## Planning, Land Use and Mobility Committee Report DIR 2020-882-DRB-SPP-MSP

*(DIRector of Planning, Design Review Board, Specific-Plan Project Permit Compliance, Mulholland Specific Plan)*

- PLUM Meetings: January 7, 2021 (Second presentation)  
November 19, 2020 (First presentation)
- Site Location: 4505 N. San Blas Avenue  
Woodland Hills, CA 91364
- Project: Application for Director's Determination of Project Permit Compliance for construction of a 3-story, 2,986 (3,101) SF Single Family Residence in the Girard Tract and the outer core of the Mulholland Scenic Parkway Specific Plan.
- Applicant/Representative: Katherine Omelchenko  
5834 Etiwada Ave, Tarzana, CA 91356  
(818) 427-1850 [Kemelch@hotmail.com](mailto:Kemelch@hotmail.com)
- Case Manager: August Steurer, PLUM Committee Member

Landscape Plan

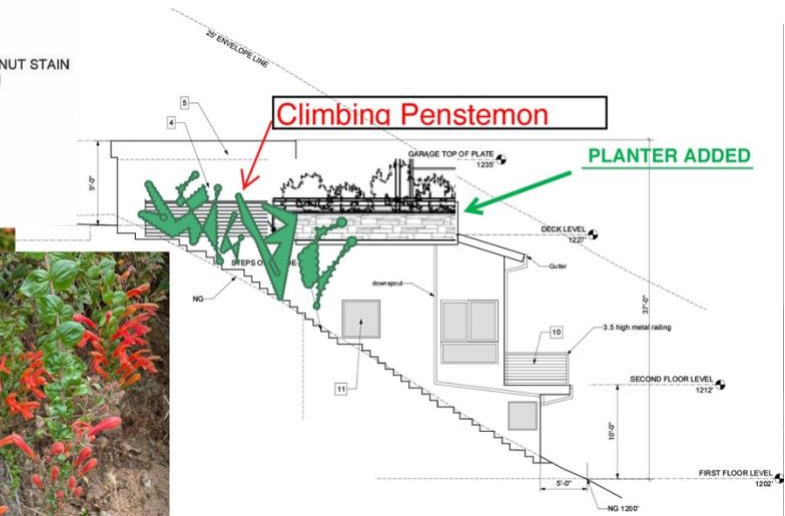
At the recommendation of the PLUM Committee, Climbing Penstemon has been added to the project of the north façade to mitigate the large expanse of blank wall facing the adjacent neighbor along with additional planters next to the rooftop parking.
